# Access Compliance Report

## Public Rights-of-Way

Intersection ID: 10027881	Main Street: HAMPSHIRE_HILL_RD	Cross Street: N/A	Location: E
ADA ID: C269793C0385	Ramp Type: Perp	Initial Pass/Fail: Pass	Overall Compliance: No
Severity Score: 10.25			
Codes/Mitigation Info/Possible Solution		Field Measurements/Component Compliance

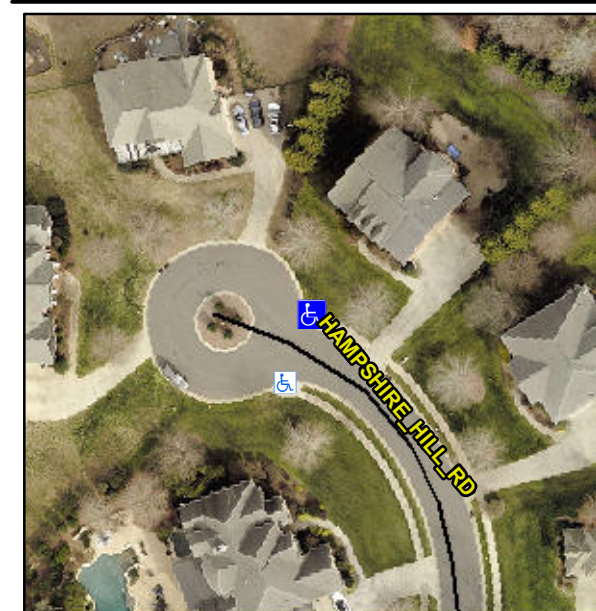
**Not Found, R304.5.3, R304.2.1,  
R304.2.2-Perp, R304.3.2-Para,  
R305.2**

Compliance	Description	Data	Compliance	Description	Data
N/A	Ramp Length (in)	70.5	Yes	Ramp Slope (%)	5.5
Yes	Ramp Width (in)	56.0	No	Ramp XSlope (%)	2.5
N/A	Flare Type LT	Sloped	N/A	Flare Type RT	N/A
N/A	Flare Slope LT (%)	1.4	N/A	Flare Slope RT (%)	2.7
N/A	Flare Traversable LT?	No	N/A	Flare Traversable RT?	No
No	Landing Length (in)	N/A	Yes	DWS Provided?	Yes
No	Landing Width (in)	N/A	Yes	DWS Contrast?	Yes
No	Landing Slope (%)	N/A	Yes	DWS Length (in)	24.0
No	Landing X Slope (%)	N/A	Yes	DWS Full Width?	Yes
N/A	Landing Curb? (Y/N)	No	No	DWS Offset (in)	8.0
N/A	Shared Landing?	No			
Yes	Gutter Ponding?	No	Yes	Gutter Slope (%)	1.7
Yes	Gutter Lip Ht (in)	0.0	No	Gutter X Slope (%)	2.4
N/A	Painted X Walk1?	No	N/A	Painted X Walk2?	N/A
	X Walk 1 Direction	To SW		X Walk 2 Direction	N/A
N/A	X Walk 1 Width (in)	N/A	N/A	X Walk 2 Width (in)	N/A
	X Walk 1 Slope (%)	2.8		X Walk 2 Slope (%)	N/A
	X Walk 1 X Slope (%)	0.8		X Walk 2 X Slope (%)	N/A

N/A	Ramp inside XWalk1?	N/A	N/A	Ramp inside XWalk2?	N/A
	Road Slope (%)	N/A	N/A	Clear Space?	Yes
	Road X Slope (%)	N/A	N/A	Clear Space to XWalk (in)	N/A
Yes	Any Obstructions?	No	Yes	Storm Grate/Utility Hazard?	No
	Obstruction Type			Storm Grate/Utility Type	
		N/A			N/A
			Yes	Surface Condition? (G/P)	Good

**Remove & Replace Entire Ramp.  
Remove & Replace Gutter.**
